STAFF RECOMMENDATION
322 Harvard Ave
July 21, 2021

Application: New Construction - Addition
District: Richland-West End Neighborhood Conservation Zoning Overlay
Council District: 24
Base Zoning: RS7.5
Map and Parcel Number: 104050184.00
Applicant: Van Pond
Project Lead: Jenny Warren, jenny.warren@nashville.gov

<p>Description of Project: New construction of an addition.</p> <p>Recommendation Summary Staff recommends approval with the following conditions</p> <ol style="list-style-type: none">1. The footprint shall not be extended further to the rear;2. Staff review and approve the final windows, doors and roofing color prior to purchase and installation; and,3. The HVAC shall be located behind the house or on either side, beyond the mid-point of the house, and utility meters shall be located on the side of the building, within five feet (5') of the front corner. Alternative mechanical and utility locations must be approved prior to an administrative sign-off on building permit(s); <p>finding that the project meets II.B of the <i>Richland-West End Neighborhood Conservation Zoning District: Handbook and Design Guidelines</i>.</p>	<p>Attachments</p> <p>A: Photographs B: Site Plan C:

PROPOSED NORTH-EAST + NORTH-WEST ELEVATIONS

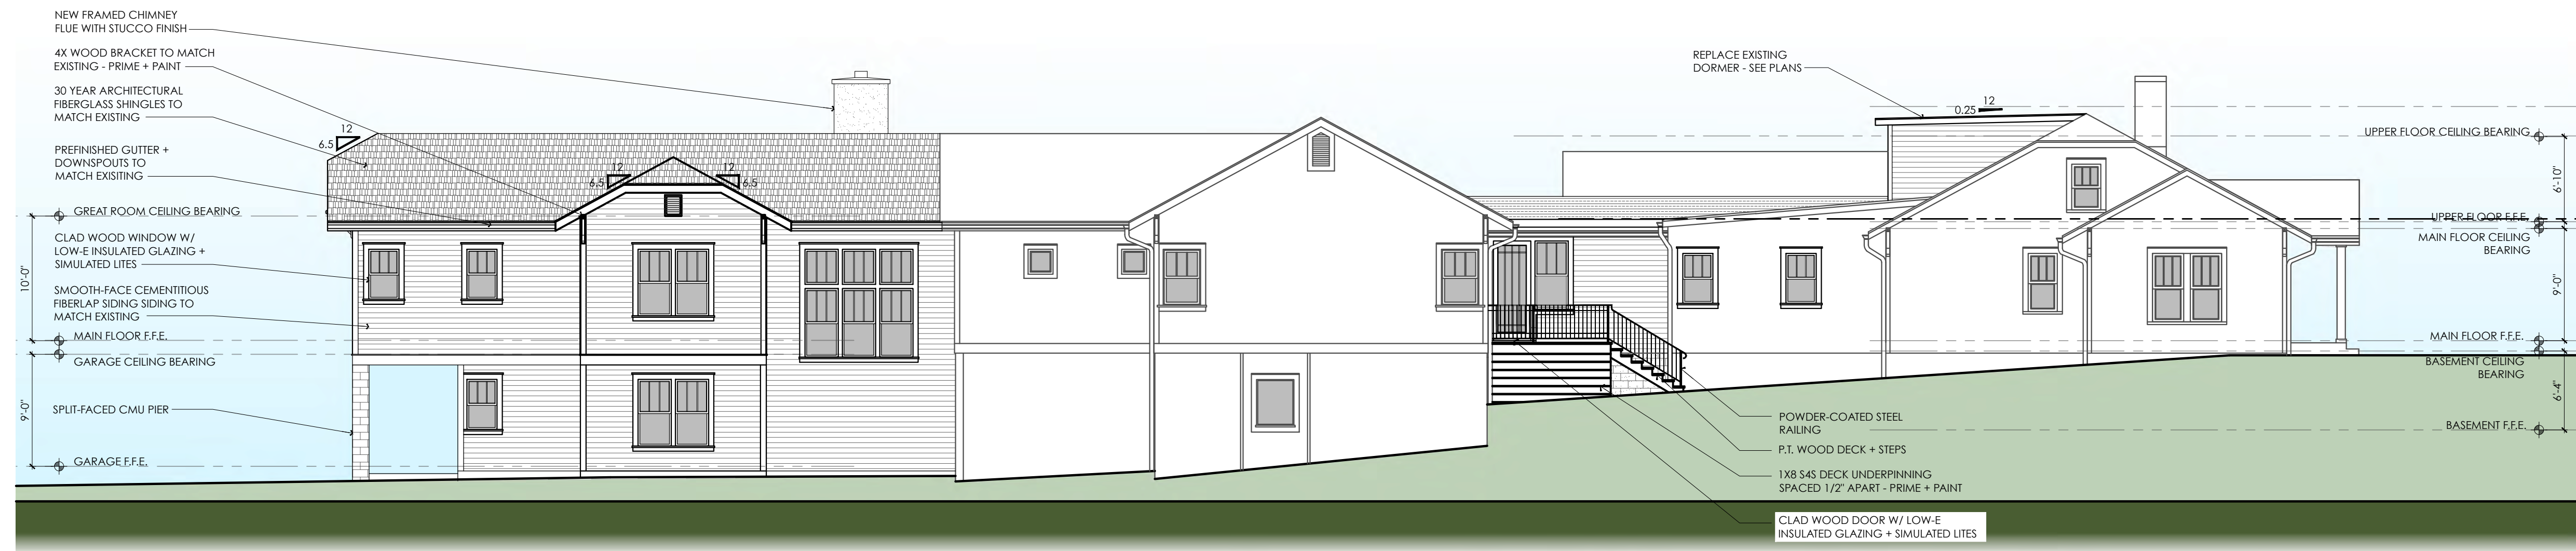
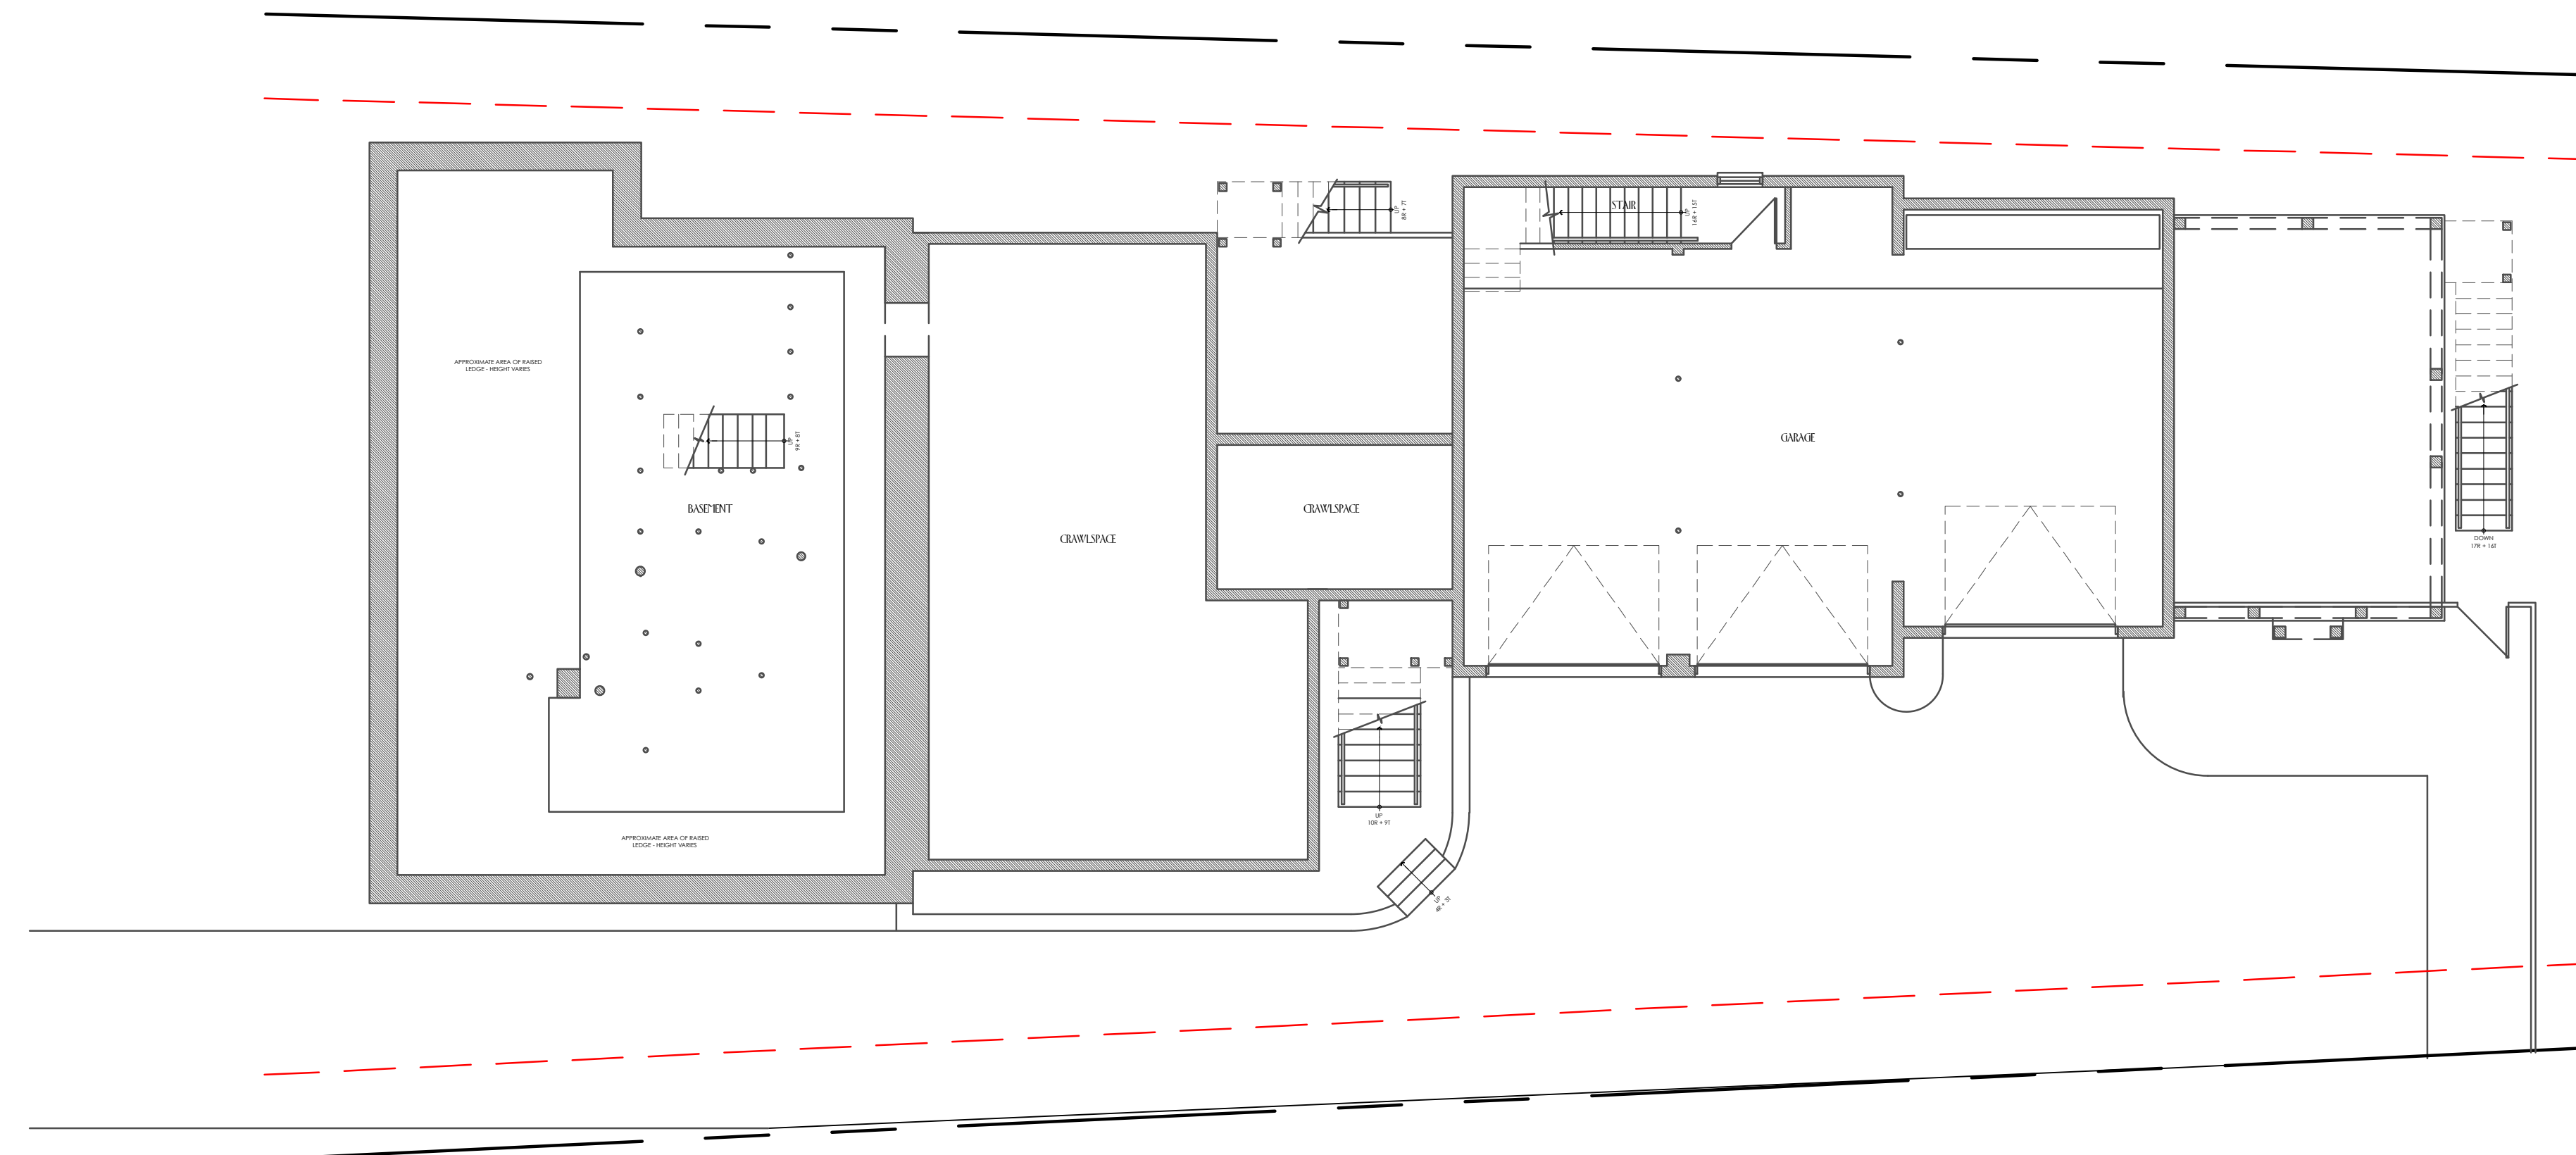
Roof form: The addition uses a rear-facing gable with a 6.5/12 slope and two side-gables with the same slope. This roof form and slope are both appropriate to the neighborhood.

Proportion and Rhythm of Openings: No changes to the historic window and door openings on the historic portion of the existing house were indicated on the plans. The windows on the proposed addition are all generally twice as tall as they are wide, thereby meeting the historic proportions of openings. There are no large expanses of wall space without a window or door opening. Staff finds the project's proportion and rhythm of openings to meet Section II.B.1.g.
